# SERVICE ADVISORY

NO.: 1530 Rev A

SUBJECT: Potential Loss of FMS Navigation and Synthetic Vision (SVT)

Figure 1 - Descent Tab of the VNAV Profile Page Showing the VNAV Descent Angle

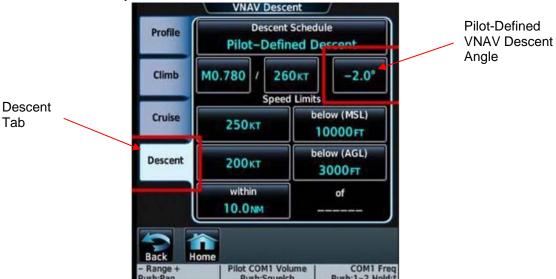
If the pilot-defined VNAV descent angle (Descent tab of the VNAV Profile page, see Figure 1) is less than or equal to the minimum allowable (shallowest) setting, SVT, FMS, AFCS (if coupled), and navigation functions may be interrupted for up to ten seconds. The condition will clear after ten seconds and all functions will resume normally.

For the G3000 Cessna Citation CJ3+ and G3000 Cessna Citation M2 do not set the pilot-defined VNAV descent angle at or below the minimum allowable (shallowest) setting (-2.0°).

For the G5000 Cessna Citation Sovereign and the G5000 Cessna Citation X+ do not set the pilot-defined VNAV descent angle below the minimum allowable (shallowest) setting (-0.5°).
